Amended Drainage Report / Final Drainage Report

Midtown Courts

1417 Railroad Avenue

1.3. MODIFICATIONS TO THE PRE-LIMINARY DRAINAGE REPORT

Weir Detail at Basin:

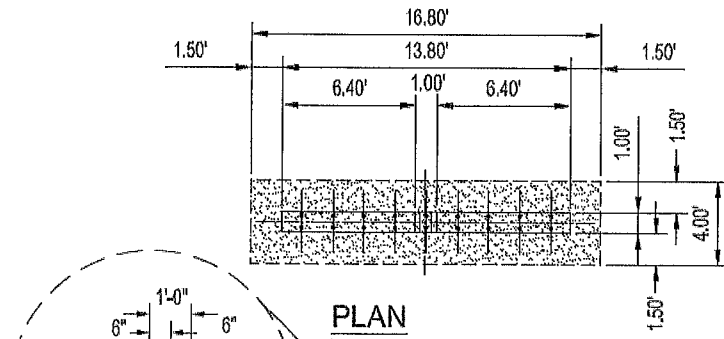
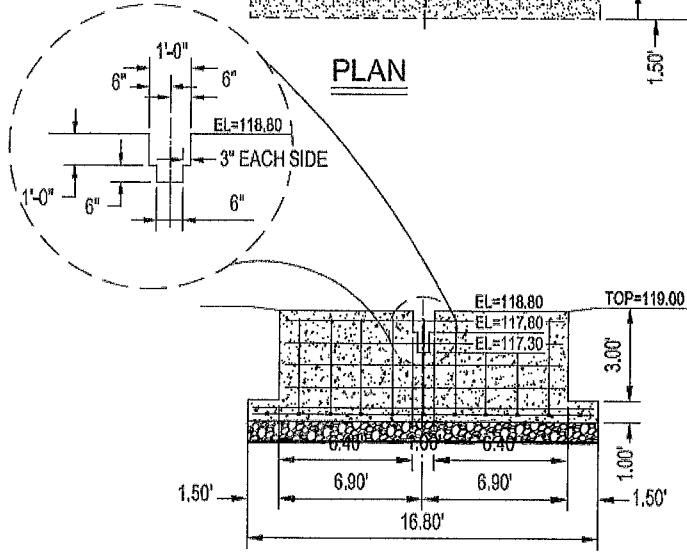
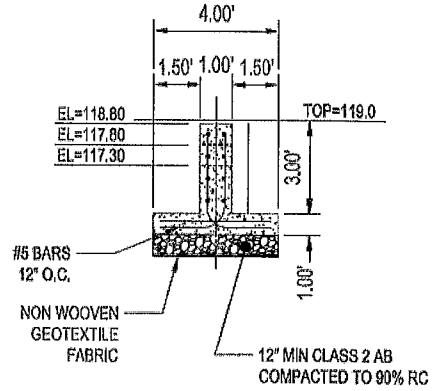
The pre-liminary drainage report remains unchanged except for one design consideration in Section 3.2 Outlet and Overflow Structure Design. This section details the overflow connection into the existing DI and as shown in the preliminary drainage report and it has been identified as a potential clogging situation presenting challenges with maintenance.

The revised approach incorporates a notched concrete weir (Exhibit B) at the outlet from the drainage basin. The sizing of all drainage facilities remains as called on in the preliminary report and the low flow and high flow overflow elevations of the weir and the outlet structure designs are shown below.

- 3500 PSI CONCRETE
- EXCAVATE TO FIRM SOIL
